CABINET MEMBER FOR ENVIRONMENT – 16 JULY 2020

DIDCOT – LARCH DRIVE & DIAMOND DRIVE: PROPOSED BUS GATE

Report by Interim Director of Community Operations

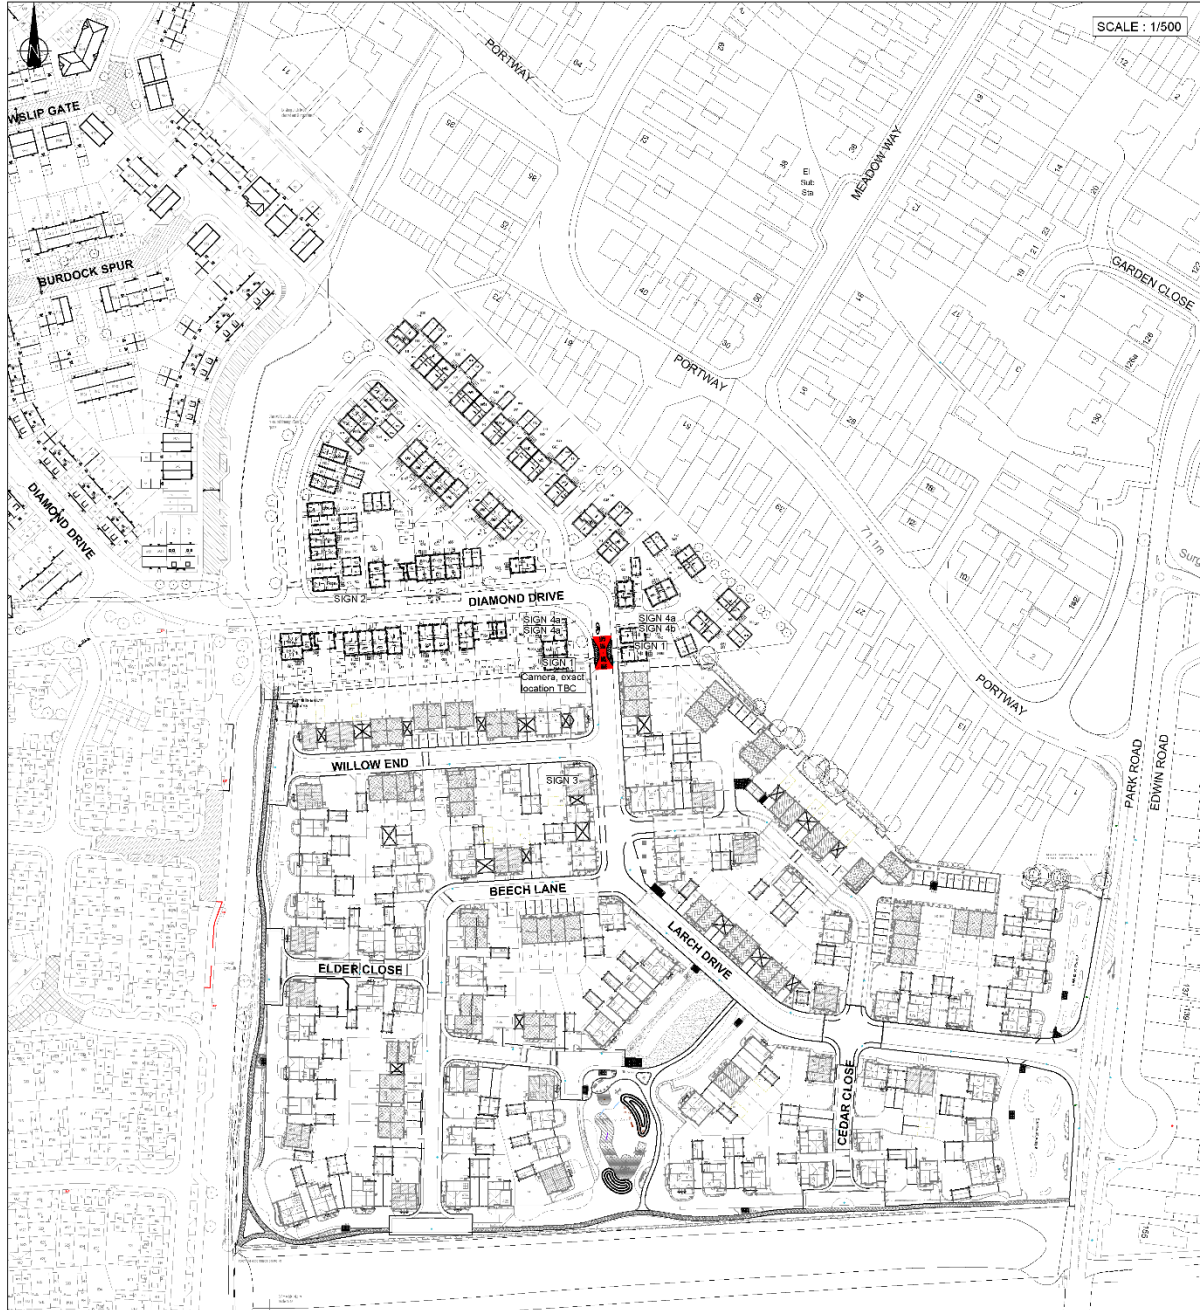
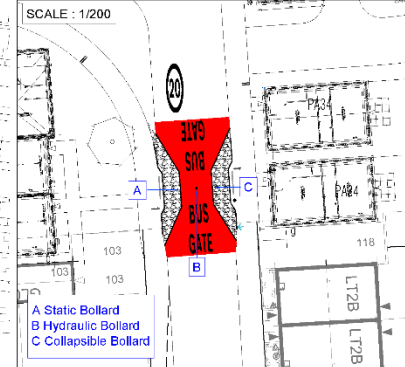
6. Thames Valley Police did not object but did ask if a road safety audit had been carried out in respect of the proximity of the proposed bus gate to the bend and also whether consideration was being given to parking restrictions in the vicinity of the bus gate to ensure that buses using the link were able to use travel through the gate.

10. Another member of the public objected on the grounds that further signing was needed to clearly show that this was not a through route for general traffic. The objection also requested that motorcycles were exempted from the restriction to avoid the nuisance of motorcyclists stopping and switching off their engines and then pushing their motorcycles through the restriction then re-starting them. This response also queried whether the proposed siting of the bus gate was in the best location, with a site further west suggested as an alternative.

RESPONDENT	SUMMARISED COMMENTS
(1) Traffic Management Officer, (Thames Valley Police)	<p>No objection – In principle I do not object providing as confirmed the restriction is self-enforcing and must not be in any way reliant on police enforcement.</p> <p>I do have two concerns regarding the location. The feature is positioned immediately following a 90-degree bend with little forward visibility. Can you confirm if a Safety Audit has already been completed and does it confirm this location is suitable for this control measure.</p> <p>As shown in the photo there is a vehicle parked close to the feature. What measures will be included to prevent this should it become a future problem.</p>

<p>(5) Local Resident, (Didcot)</p>	<p>Object - 1. (This is only an observation) I think the bus gate might have more naturally been placed between BLUE BELL GATE and BOX TREE LANE. I don't feel it is appropriate to form an opinion on the location for this planned bus gate without a documented description of the rationale for its placement in preference to any other options. However, as presented I would have no 'objection' to either.</p> <p>2. (This is an OBJECTION to the road signage plans; they are insufficient) The plans also need to include the details of 'NO THROUGH ROAD' signage, and/or in addition to further signs, at least being placed by or before COWSLIP GATE. Probably also right at, and in the approaches to, the main junction with Didcot Road and the estate entry road. The signs on Didcot Road should show a red bar with a junction layout sign, and say "NO THROUGH ROAD" or "NO THROUGH ROAD TO COSCOTE", "ACCESS TO RESIDENTIAL ONLY" or similar. This should have been done already and is an omission not to have done so by now.</p> <p>This comment also applies to the approach to Larch Drive from Coscote into/out of Didcot and should read 'NO THROUGH ROAD TO DIAMOND DRIVE'.</p> <p>3. (This is an OBJECTION to making transit by mopeds/motorcycles unlawful) I comment that perhaps access for motorcycles through the bus gate is also, formally, allowed. This is not for any interest in motorcycles, but my understanding would be that if a motorcyclist were to stop before the gate, turn their motorcycle off, walk it through the gate, and start it back up, then this would be lawful. It would make an ass of the law to force a motorcyclist to do just that, when they could simply ride through, reducing noise and CO2 emissions compared with having to stop and</p>

7. It is confirmed that the proposed feature has been the subject of a safety assessment and it is considered that its siting close to the bend does not present a hazard given the character of the roads. Also the bend does serve to reduce speed and the bus gate will be signed. However, if approved, the operation of the bus gate will be monitored to see if waiting restrictions are required.

11. Noting the above comments provision of a bus route and bus gate through the development has been a long-standing requirement established as part of the planning process for the residential development and it is anticipated that single deck buses will operate the route. The signing of the restriction – including the provision of advance signs and the need for any additional road markings will be reviewed. The suggestion that motorcycles are permitted to use the bus gate is not considered desirable on road safety or amenity grounds for residents.
